HISTORIC PRESERVATION BOARD

HISTORIC PRESERVATION BOARD MEETING

WORKSHOP
176 EASTERN PROMENADE

TO: Chair Pollard and Members of the Historic Preservation Board
FROM: Rob Wiener, Historic Preservation Compliance Coordinator
DATE: January 5, 2022
RE: January 12, 2022 **WORKSHOP – Preliminary Review of Proposed
Dormer Additions - HPBR-001849-2021**

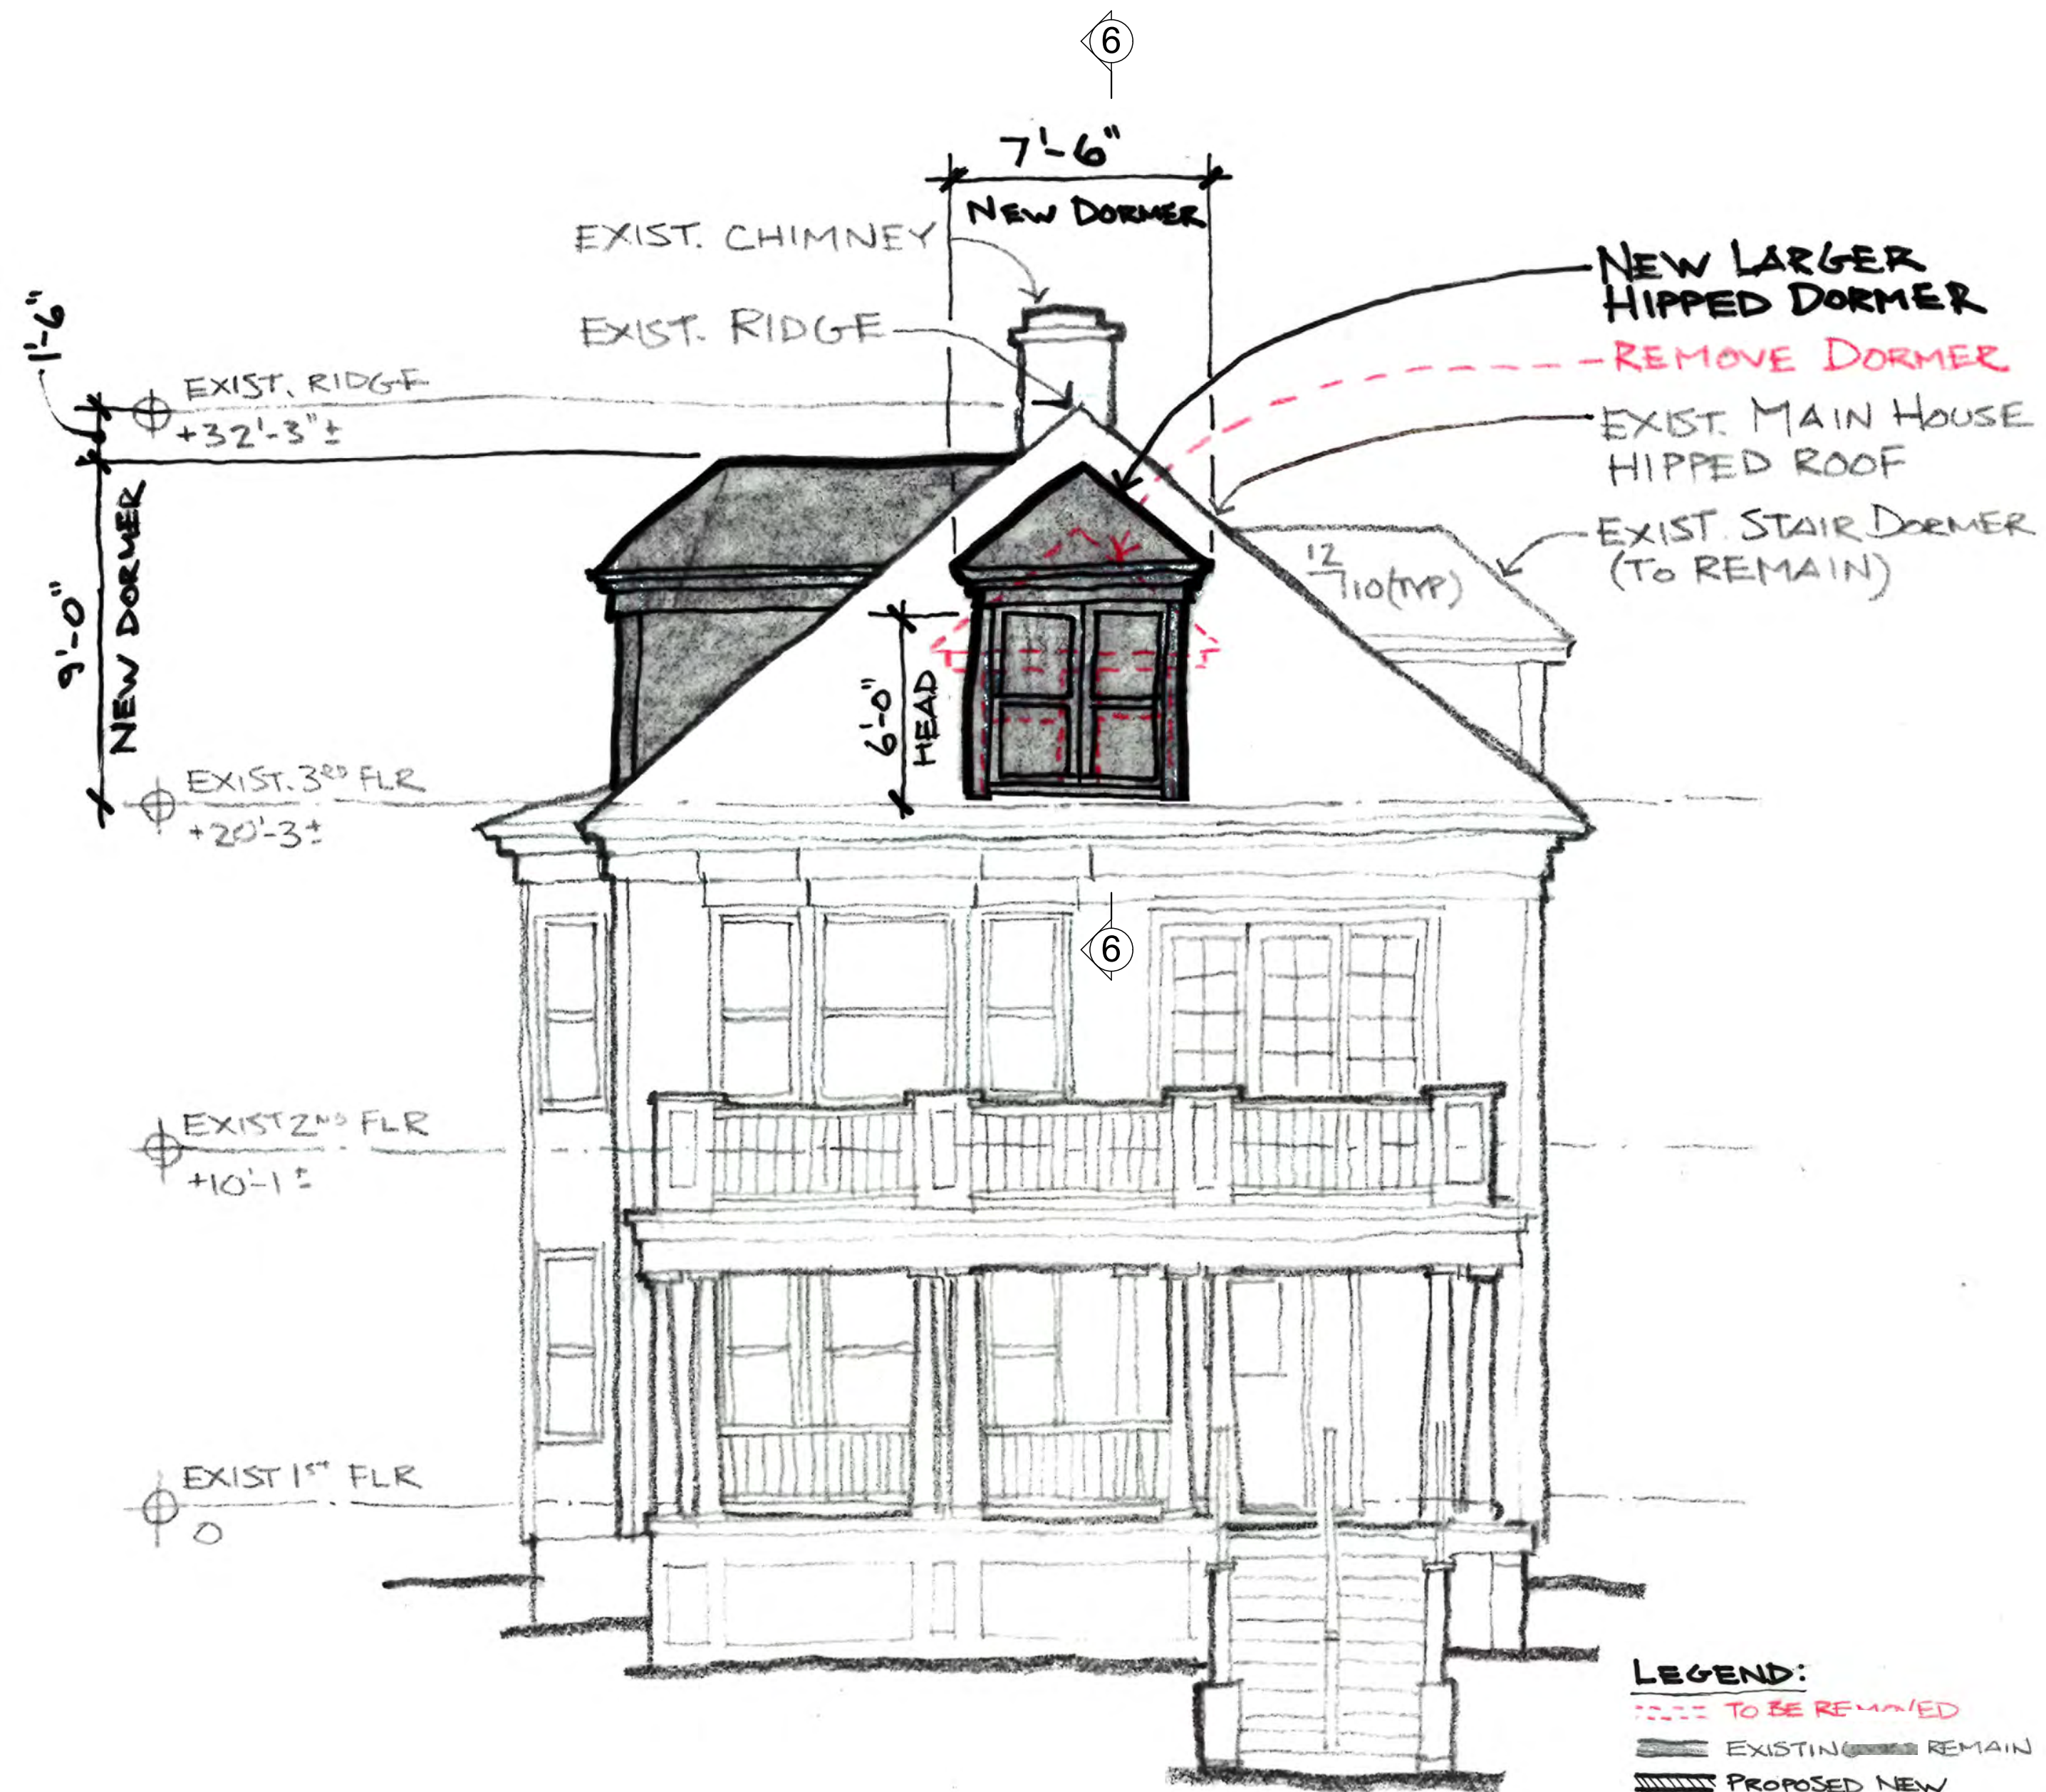
- The existing dormer on the north roof is to remain over the attic stairs, where the descent of the staircase allows for a fairly low dormer.
- Staff has requested a section drawing to clarify the location of the attic floor, the height of the proposed dormers, and the existing and required headroom heights.

- Staff notes that the project description refers to the proposed east (front) dormer being lower than the two proposed south dormers, while the elevation sketches show the dormer ridges and eaves at the same height. A revised section drawing shows the correct relationship, with the ridge of the proposed front dormer 5” lower than the ridges of the south side dormers.

- The drawings show the relative size of the existing front dormer, compared to the proposed front dormer. Views to the northeast and Casco Bay are more accessible for a standing occupant in the proposed scenario than with the low header height of the existing window.

RIGHT ELEVATION ~ DRIVEWAY
1/4" = 1'-0"

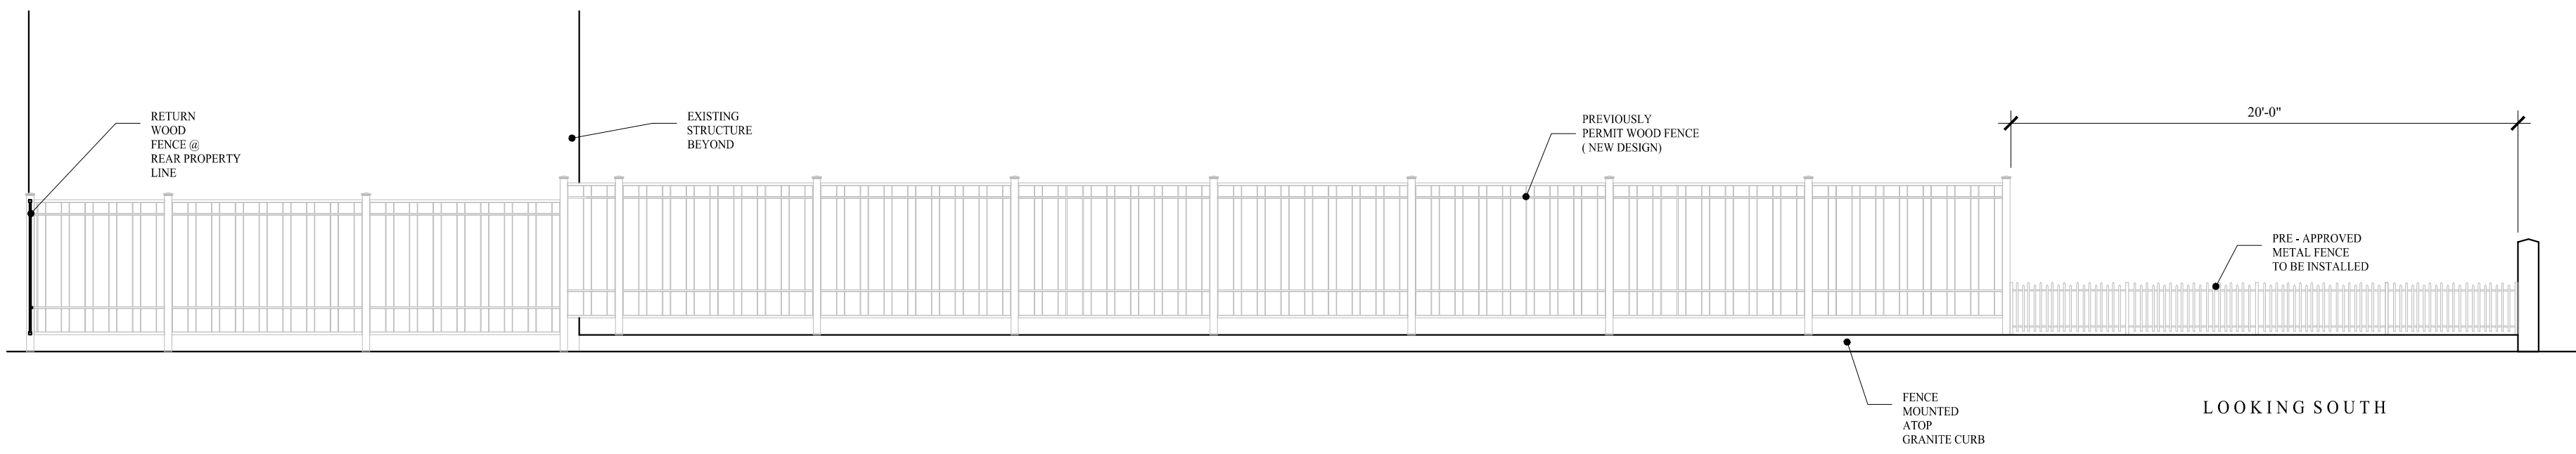
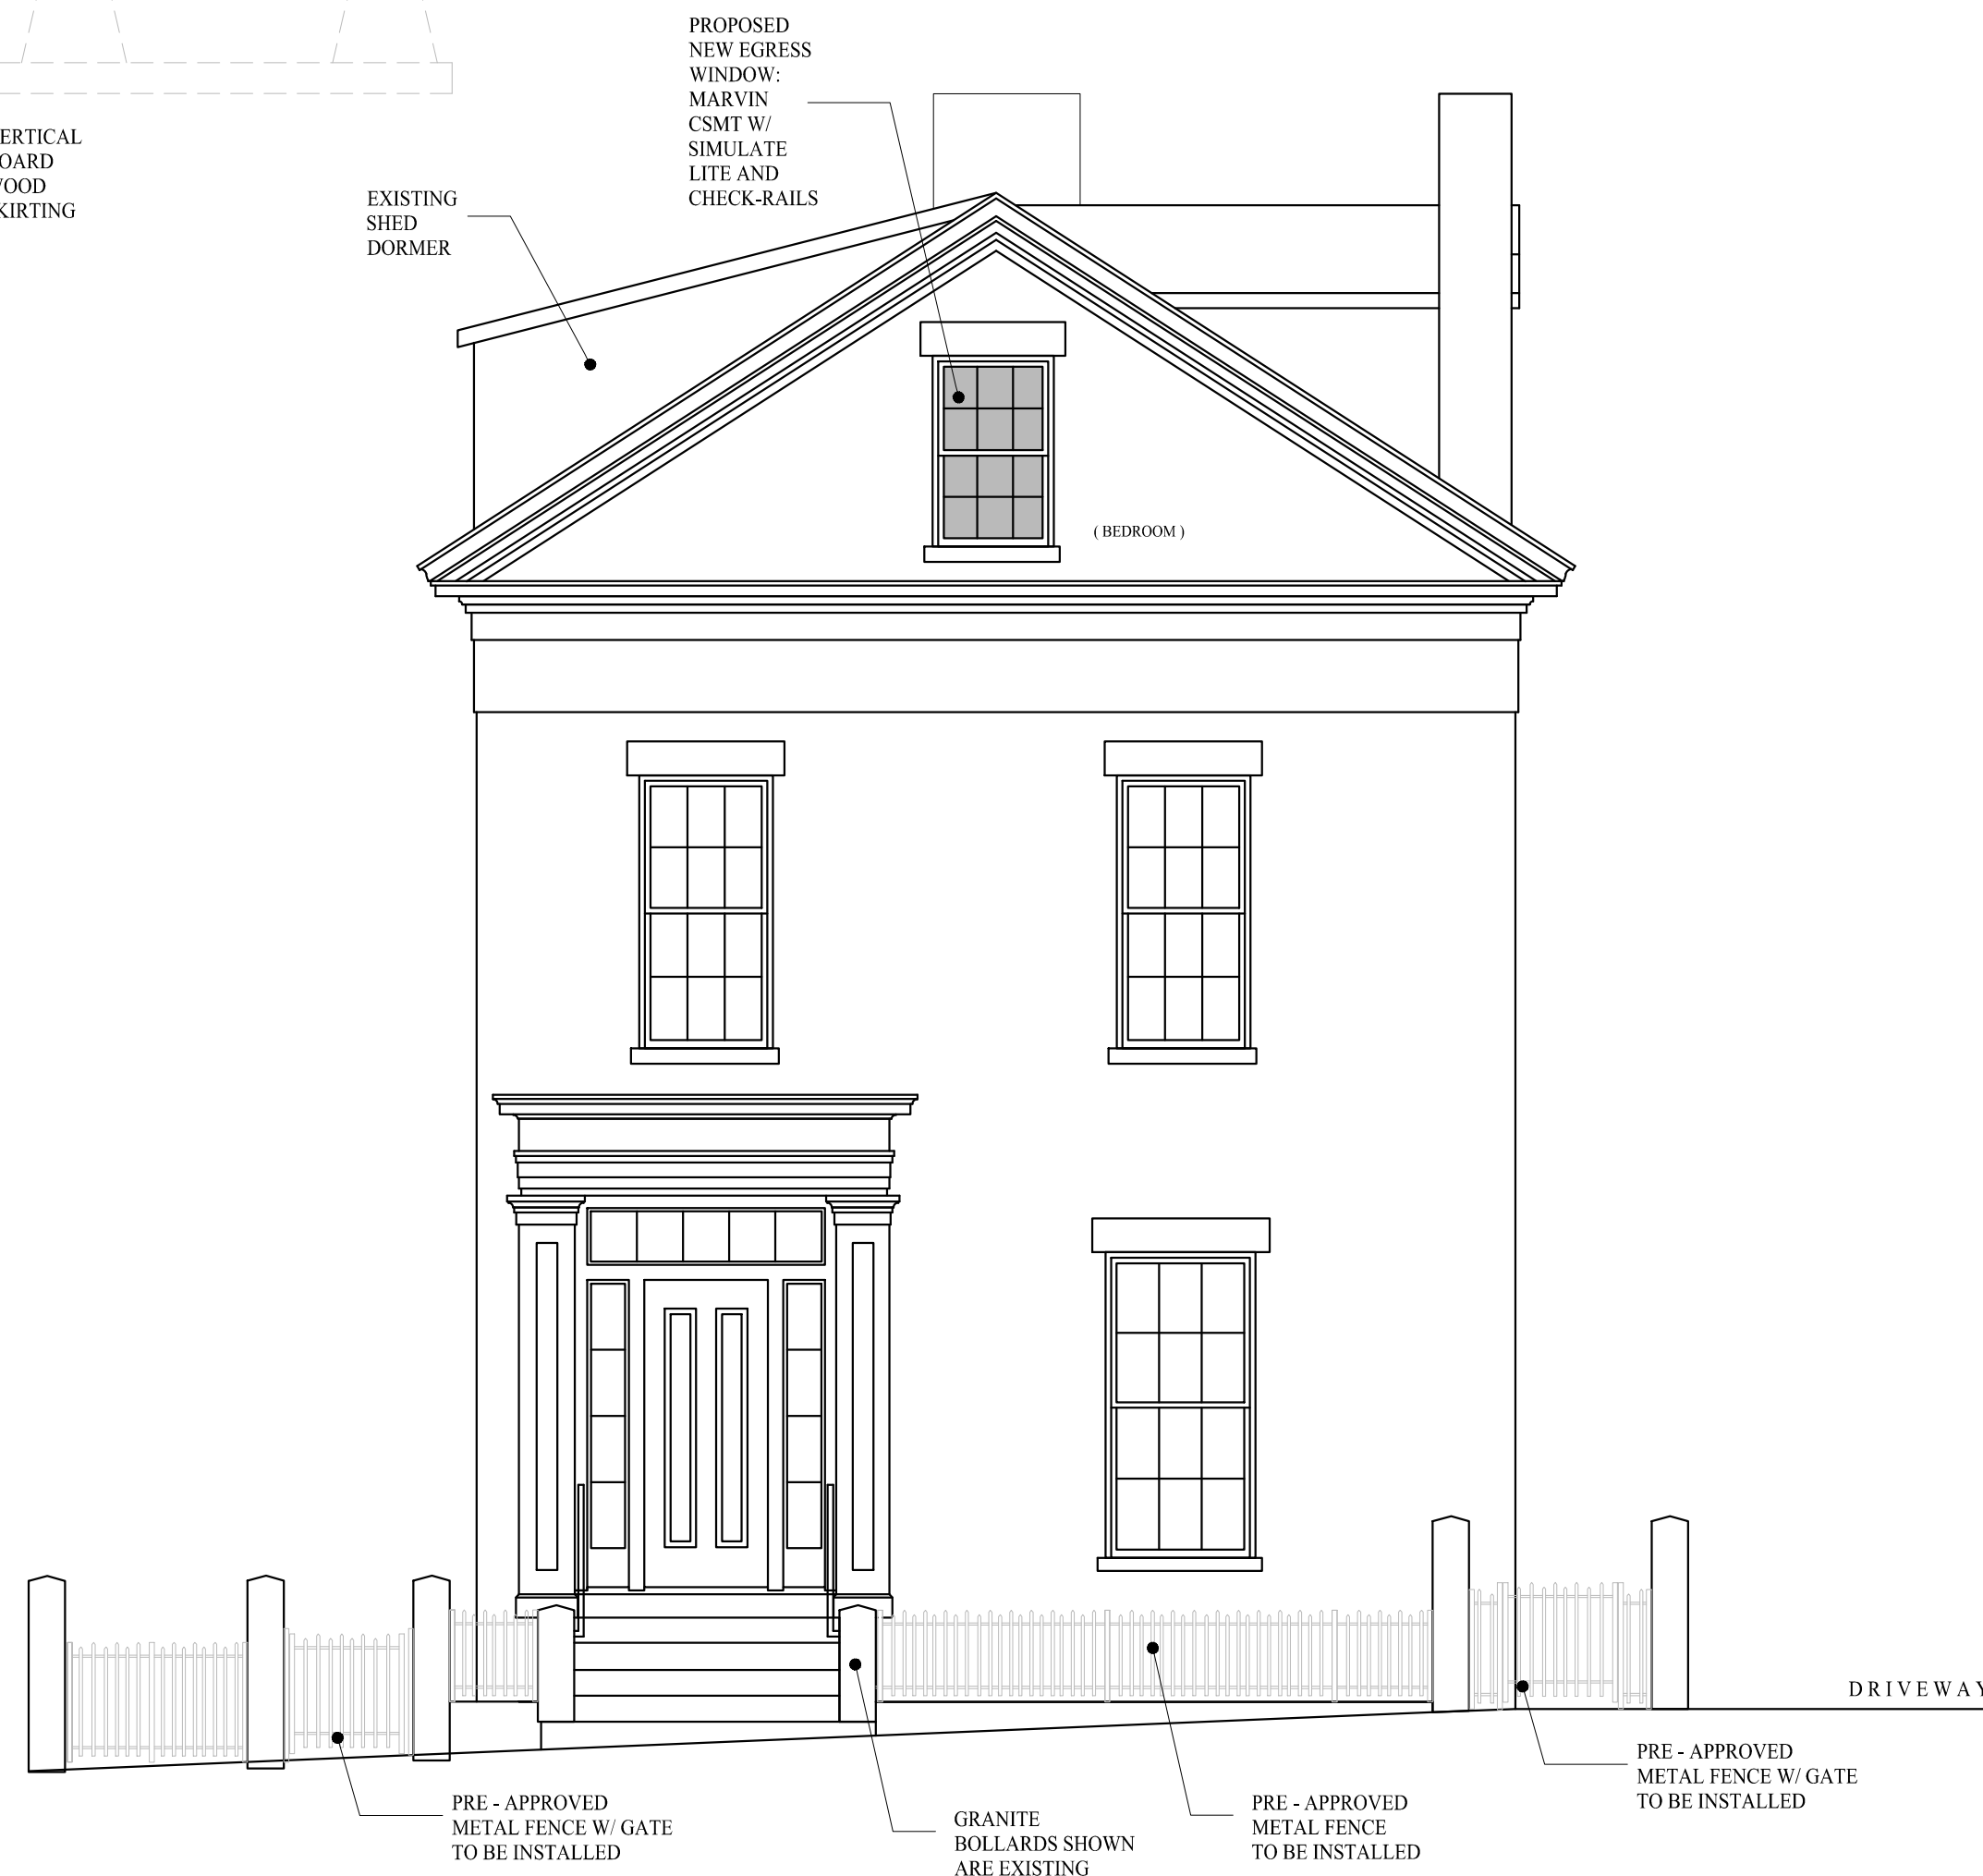
- The plans call for installation of “previously-approved” metal fencing in front of the property, but there is no detail or specification provided. As shown in 2004, the fencing appeared to be iron, not stock aluminum fencing. Additional information or a detail should be provided.
- In a previous approval, the Board stipulated that all the granite posts along the sidewalk edge be the same height. As installed, three of the posts at the west end of the property are taller. This should be corrected.
- Note that the Board had indicated a preference for no handrails at the front entrance if allowed by code. Given that the front entrance appears to serve a single unit, are handrails indeed required? (Of course, the current applicant may request a change to the previous proposal.)
- The submitted details for the west side porch and retaining railing on the east side

show round ball finials as post tops. Round ball finials are a characteristic of the Colonial Revival and Queen Anne style. Staff suggests that the post tops be simple pyramidal tops.
